Docket No. 50-336

Millstone Nuclear Power Station, Unit No. 2
Feedwater System Piping

RESPONSES TO
ADDITIONAL INFORMATION REQUIRED
TO ASCERTAIN ACTIONS NECESSARY
REGARDING THE FEEDWATER SYSTEM PIPING

FIGURE 1.

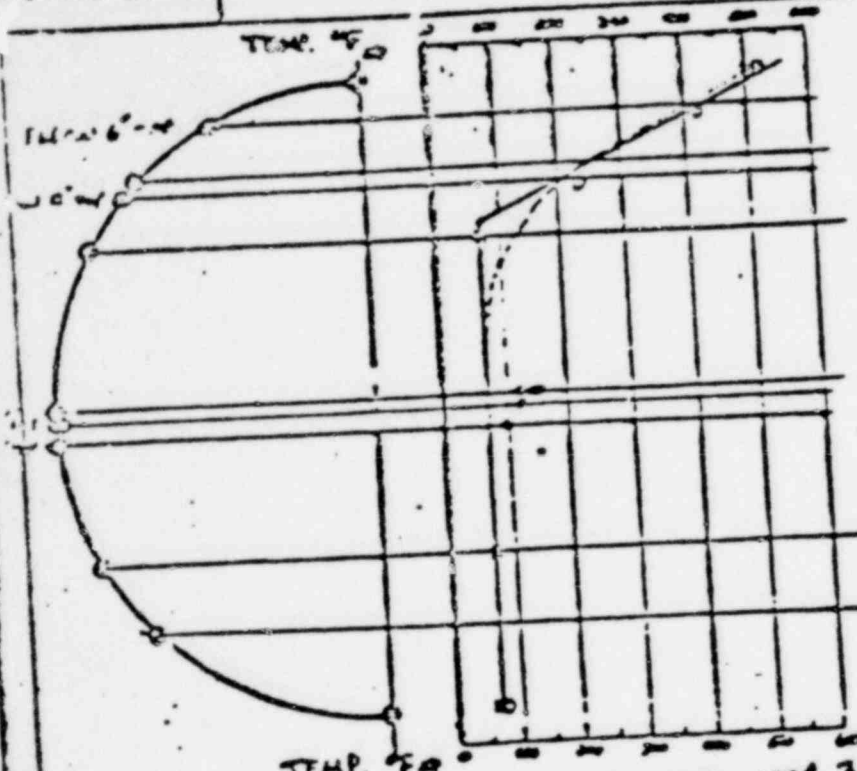
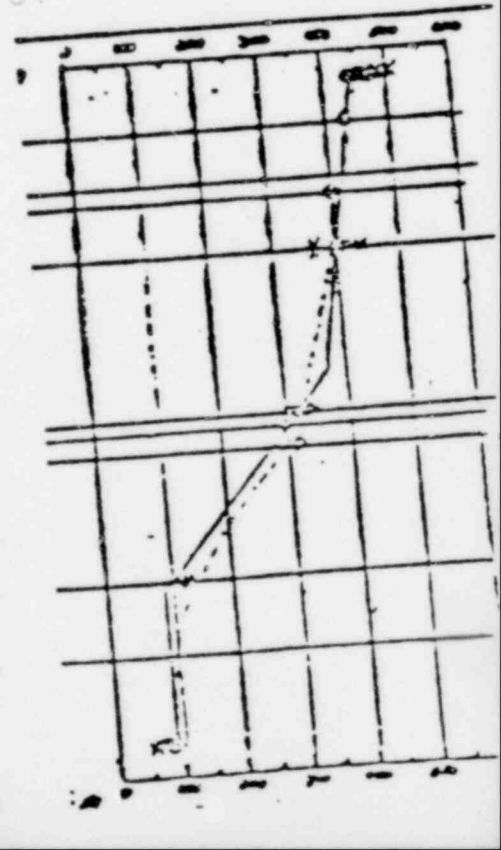
A three dimensional finite element stress analysis has been completed for each of the five temperature profiles in Figure 1, and transient studies have shown that the five profiles represent limiting conditions compared with the stress results obtained for any transient step in between the profiles.

FIGURE 2 : SUMMARY OF TEMPERATURE PROFILE OCCURRENCES

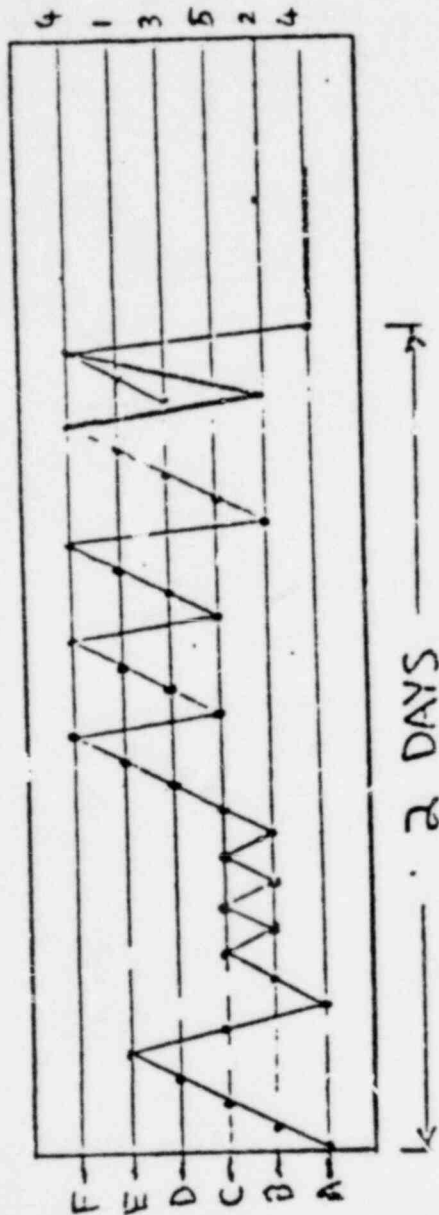
To accomplish a fatigue crack growth analysis, the system design transients for normal, upset and test conditions were combined with the cycles of stress from stratification, which occurs during hot standby operation. As shown in Figure 2, there are approximately nine cycles of various degrees which for the purpose of this analysis, we will assume, occur each time hot standby occurs.

FIGURE 2 FATIGUE CRACK GROWTH DATA FOR SA-509, CLASS 2 AND CLASS 3 AND SA-533, GRADE B, CLASS 1 STEELS

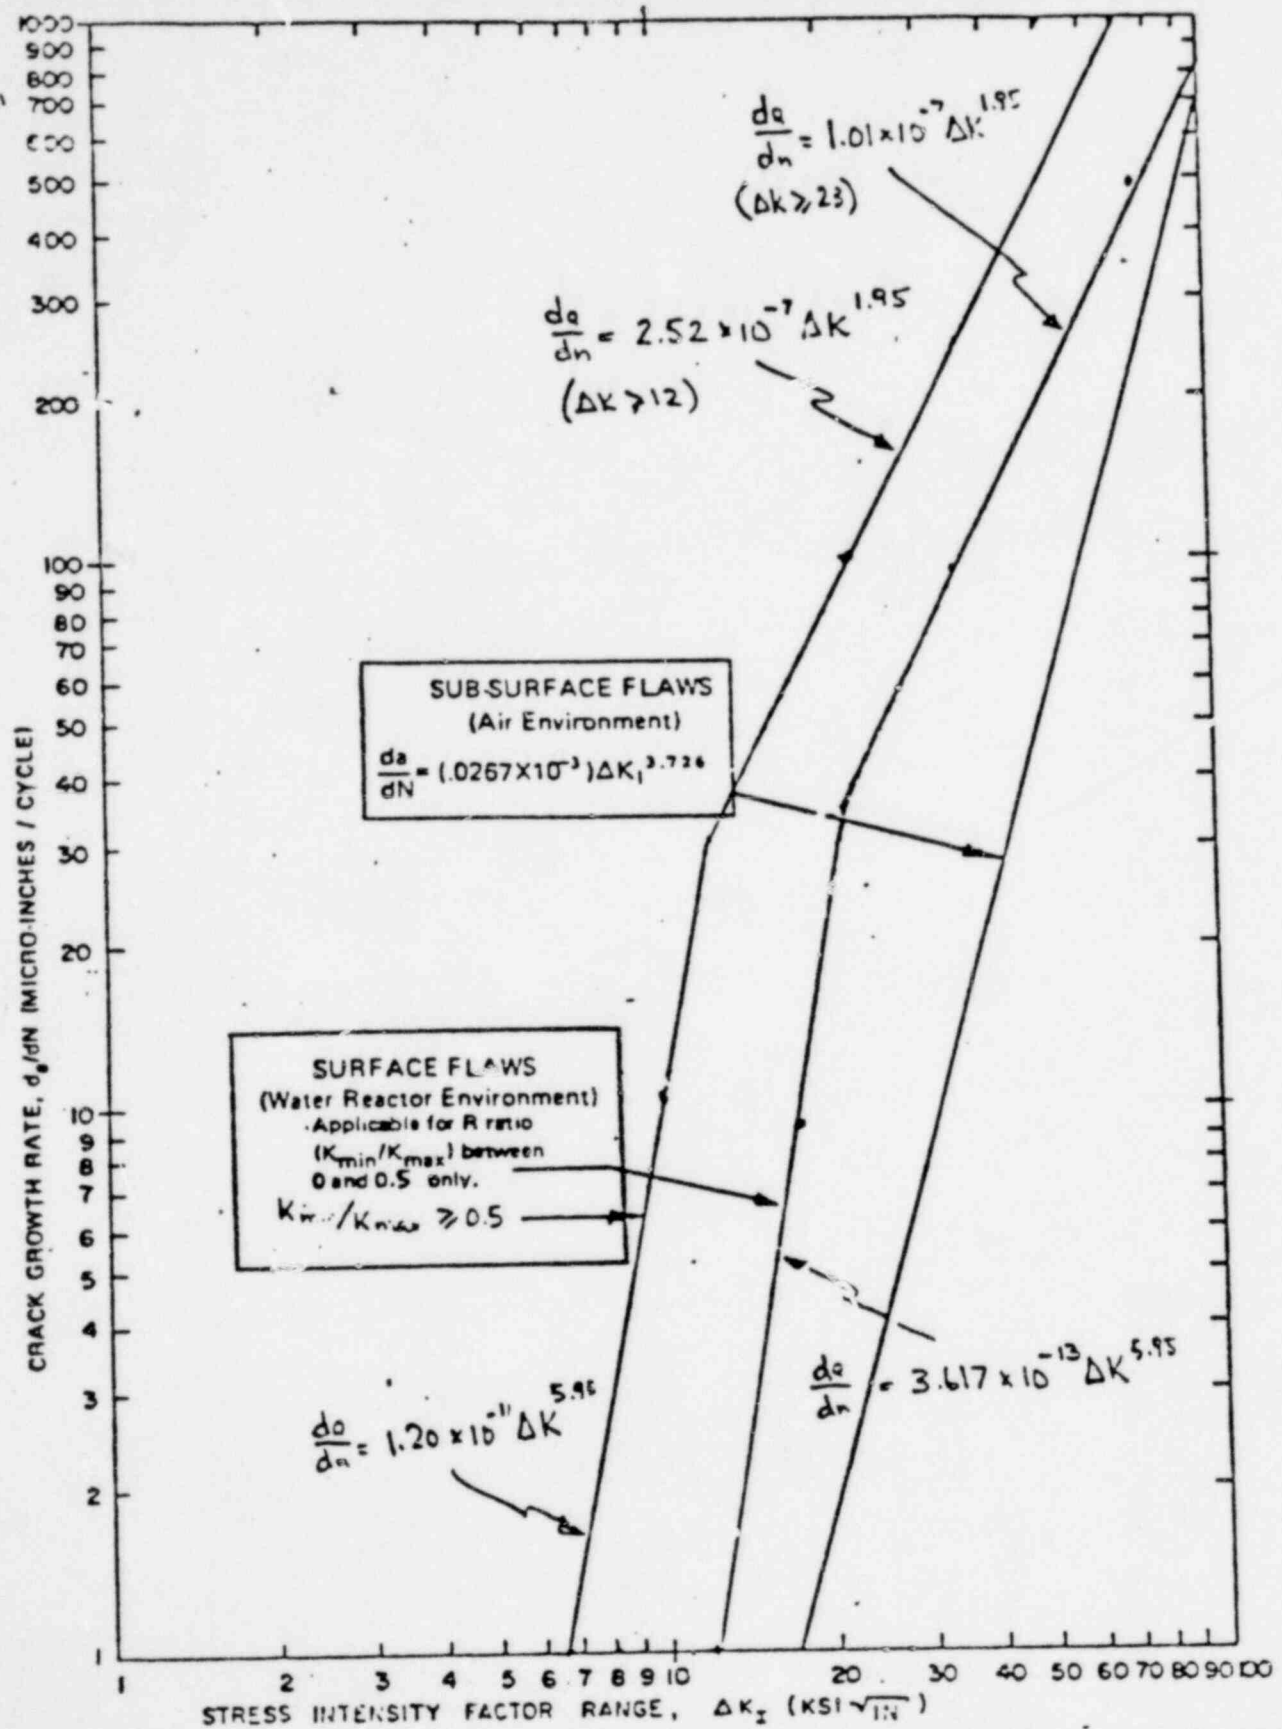
A fatigue crack growth law which accounts for mean stress or R ratio ($\sigma_{min.} / \sigma_{max.}$) as well as the presence of the water environment was used. The law is shown in Figure 3.

FIG. FAILURE PREDICTIONS - 18" ID PIPE 0.75" WALL

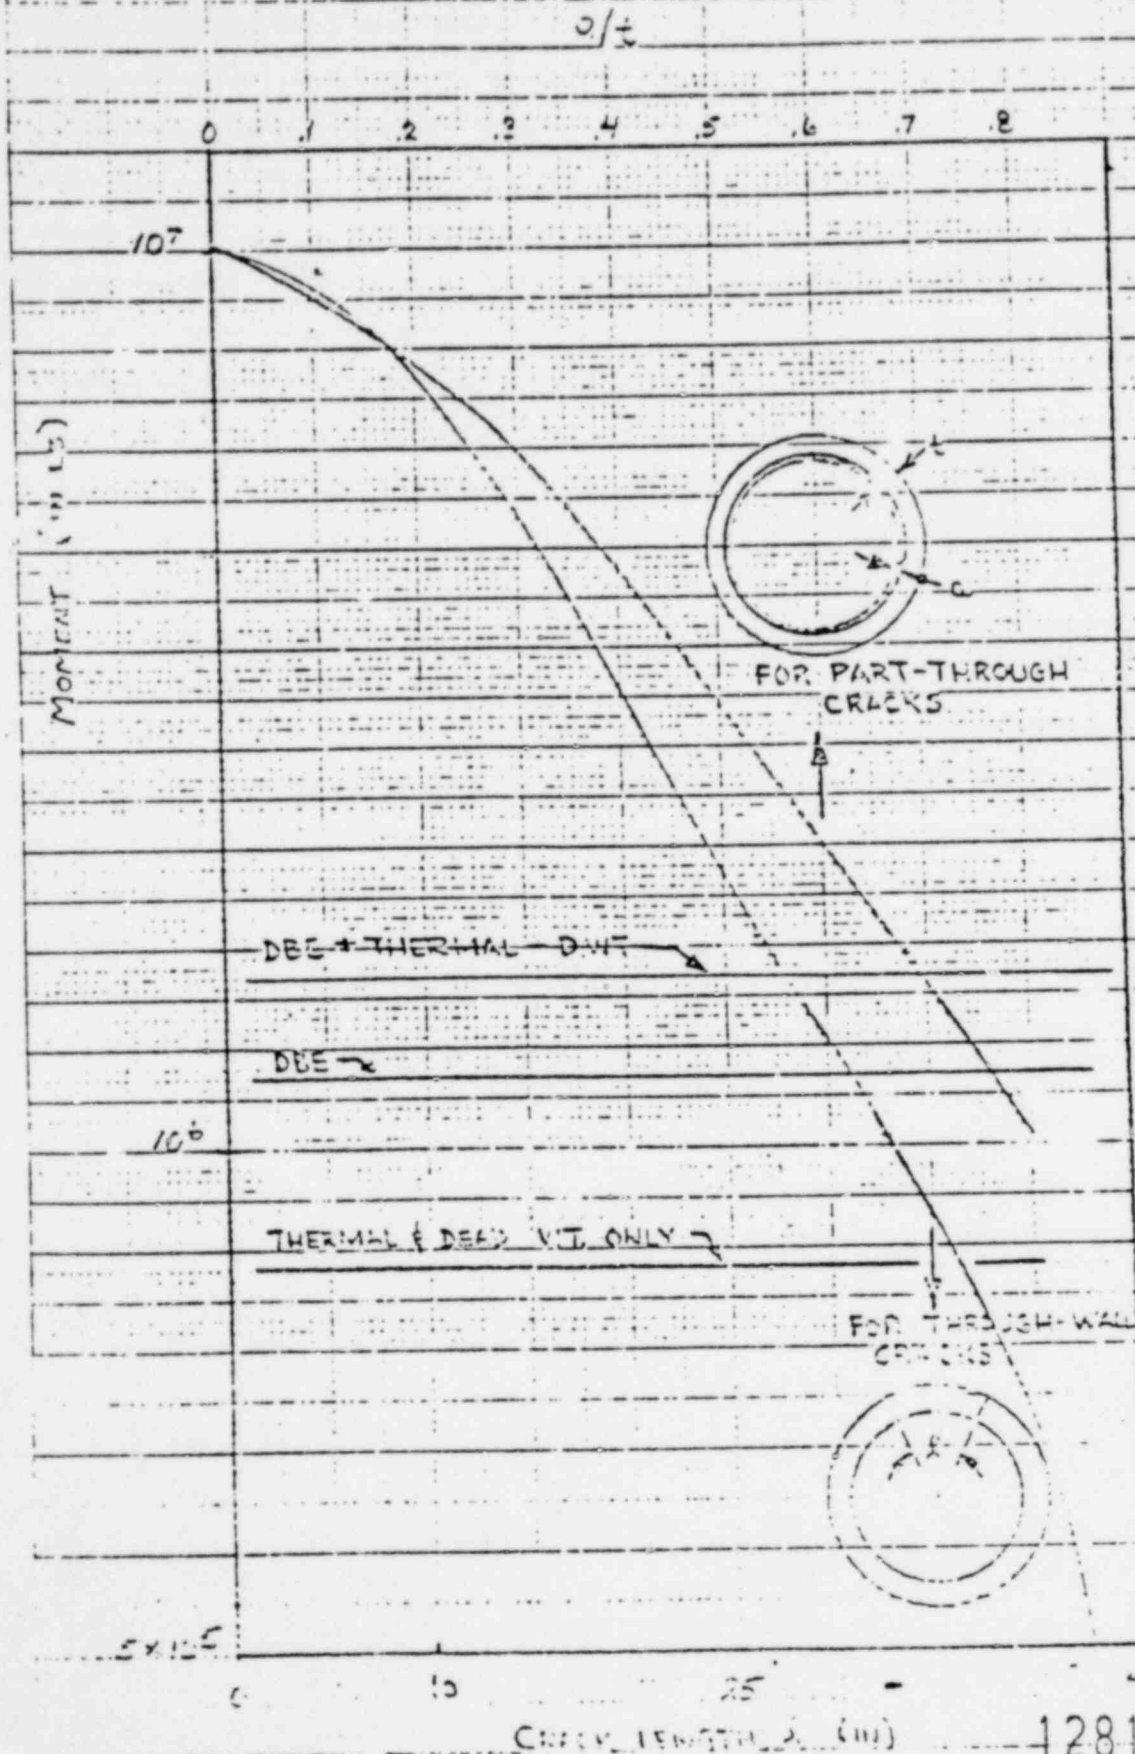
Results of the crack growth analysis are shown in Table 6, for each of the locations considered. These results show that the observe flaws will not grow significantly during the next years service. The final flaw size for the worst location is a factor of 5 smaller than the critical flaw size for the pipe, as shown in Figure 4.
